**POST CONSTRUCTION CERTIFICATION:
RETENTION POND MODIFICATION & ADDITION OF ROCK AROUND
ADMIN BUILDING**

**SEMINOLE COMBINED-CYCLE FACILITY
PALATKA, FLORIDA**

KIEWIT PROJECT NO. 20015690

REVISION 3 – ISSUED FOR INFORMATION

FIGURE 1: POND AS PERMITTED VS POND AS CURRENTLY BUILT

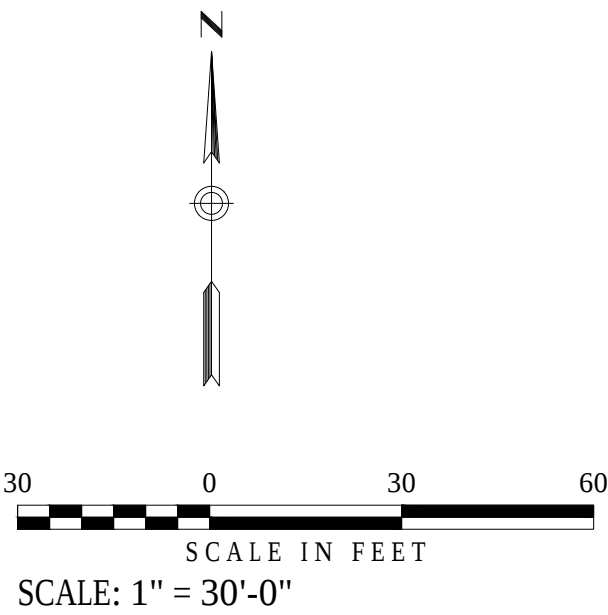
The main stormwater management feature for the Seminole Combined-Cycle Facility is the 4-acre retention pond located at the south end of the site, which acts as the outfall for the entire 51-acre drainage area. In the northwest corner of the basin, several utilities run in and around the footprint of the pond. One, an alternate power feed to the Medium Voltage enclosure, rises in grade where the construction trailers are currently located. To avoid this utility, the northern edge of the pond will be shifted 15' south as shown in Figure 1. This results in a loss of storage in the pond below the spillway of 24,599 cubic feet. Stage-storage information for the retention pond as previously permitted along with the retention pond as proposed can be found below in Tables 3 & 4.

Table 4: Retention Pond Stage Storage Table (Modified Footprint)

RETENTION POND (P-1) STAGE - STORAGE DATA						
ELEV. RANGE		CONTOUR AREA	INCREMENT		TOTAL	
		AC	CF	AC-FT	CF	AC-FT
65.00		2.20				
	66.00	2.51	102,518	2.35	102,518	2.35
66.00						
	67.00	2.86	116,853	2.68	219,371	5.04
67.00						
	68.00	3.20	131,866	3.03	351,237	8.06
68.00						
	69.00	3.56	147,177	3.38	498,414	11.44
69.00						
	70.00	3.85	161,432	3.71	659,846	15.15
WEIR EL	70.00					
TOP OF BANK	71.00	4.07	172,510	3.96	832,356	19.11

FIGURE 2: SB-1 DITCH (AM20-236 VS PROPOSED EXPANDED FOOTPRINT)

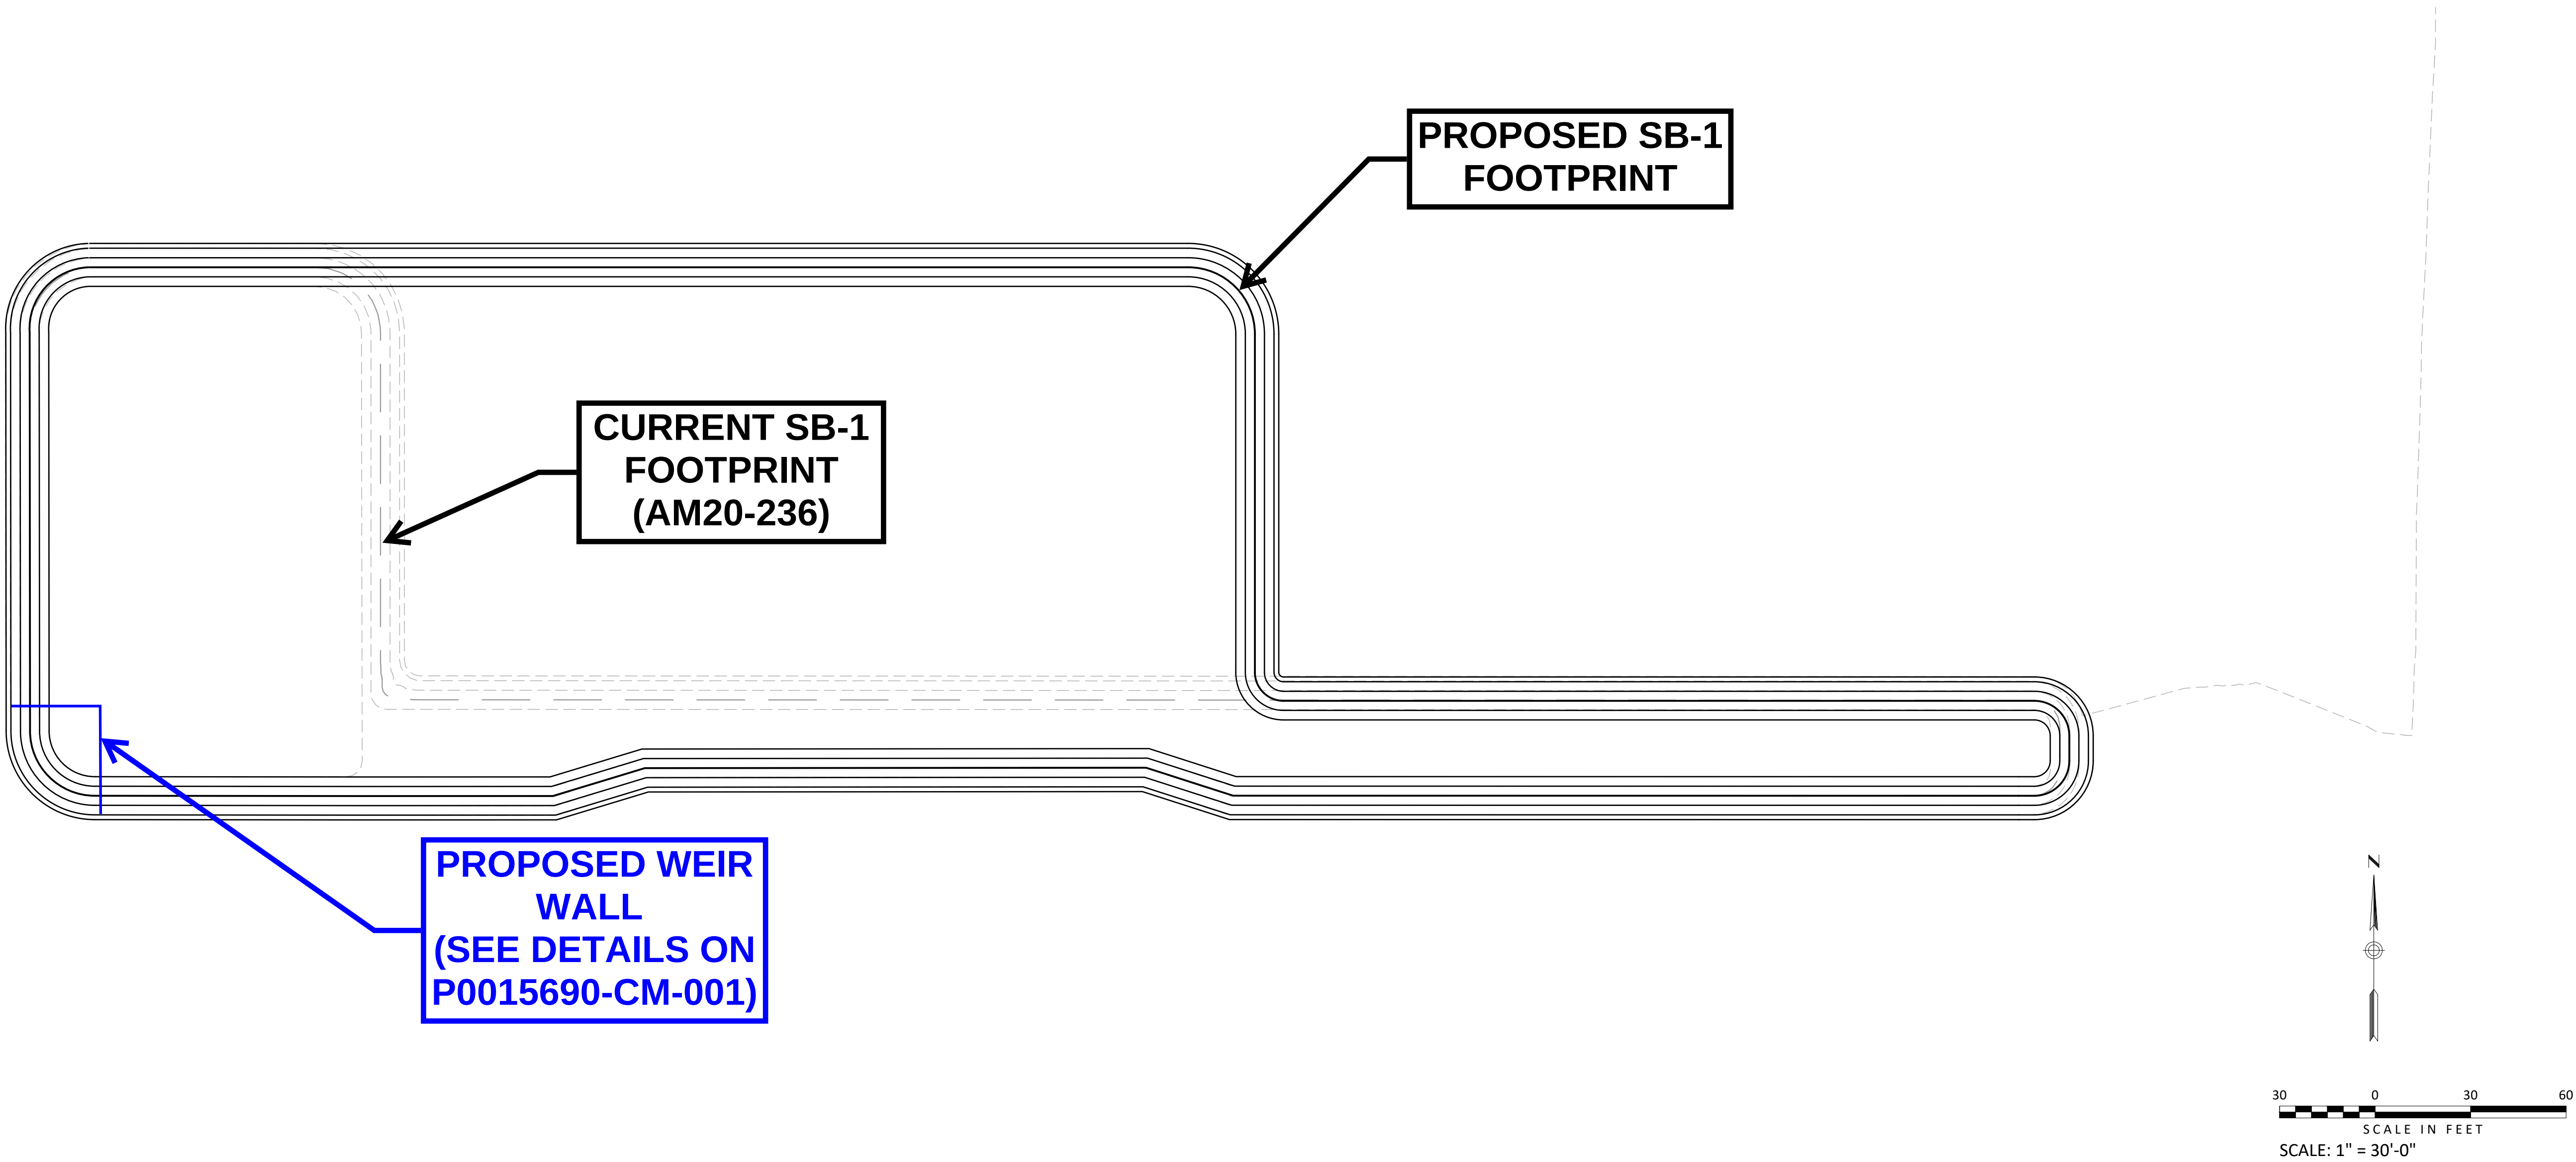
To account for the increase in runoff and loss of storage outlined in Sections 4.1 & 5.1 above, several modifications to the SB-1 Ditch will be required. The first modification consists of expanding the footprint of the SB-1 Ditch to replace the storage lost in the retention basin, which can be seen in Figure 2. Tables 5 & 6 below provide stage-storage information for the SB-1 Ditch in its current orientation (AM20-236) as well as with the proposed footprint expansion.

Table 6: SB-1 Ditch Stage Storage Information (Footprint Increase)

SB-1 Ditch Stage Storage (After Footprint Modification)		
<i>Elevation</i>	<i>Contour Area (sq. ft)</i>	<i>Cumulative Volume (cu. ft)</i>
73	60,282	0
74	64,928	62,605
75	69,630	129,884
76	74,389	201,893
77	79,205	278,690
77.5	81,634	318,900

SB-1 Ditch 25-year Max Water Surface Elevation (Expanded Footprint): 75.28

SB-1 Ditch 100-year Max Water Surface Elevation (Expanded Footprint): 76.36
